Chapter 7 – Responses to Comments

The Draft EIR for the proposed Metro Gold Line Foothill Extension – Azusa to Montclair was made available for a 45-day public review and comment period pursuant to the State CEQA Guidelines, Sections 15105 and 15087, beginning on August 5, 2012 and ending on October 5, 2012. The Metro Gold Line Foothill Extension Construction Authority also held public meetings to receive comments on the Draft EIR on September 20, 2012, at 5:30 p.m. in Montclair, and on September 24, 2012 at 5:30 p.m. in La Verne.

Marshall Canyon Trail Near Arrow Hwy and Wheeler Ave Intersection
Los Angeles County Department of Parks and Recreation

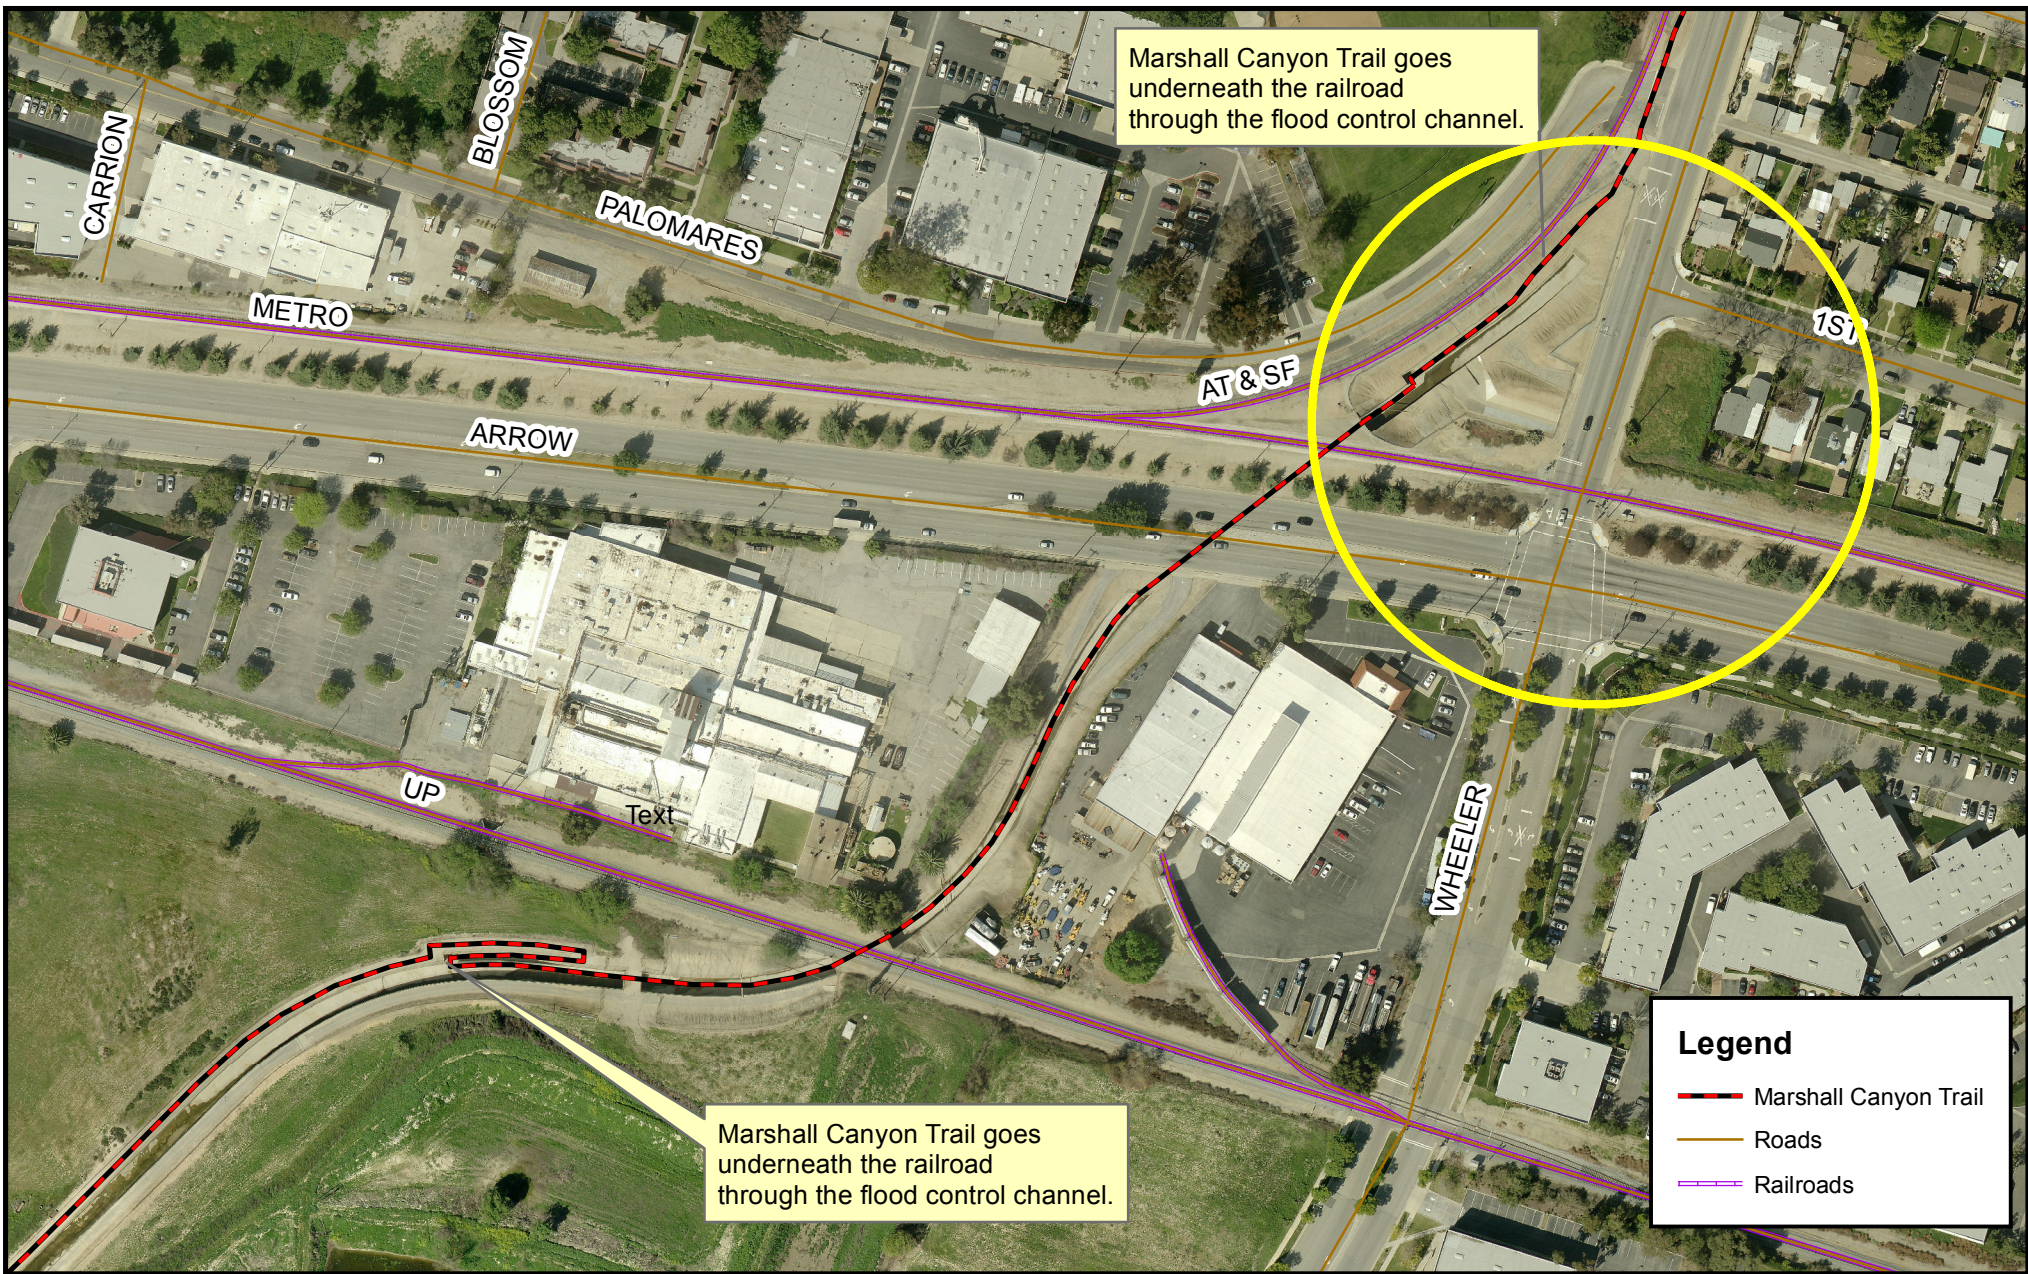
Thank you for including this Department in the environmental review process. If you have any trail inquiries, please contact Mr. Francis Yee at 213-639-6058 or fyee@parks.lacounty.gov. If we may be of further assistance, please contact me at (213) 351-5129 or jchien@parks.lacounty.gov.
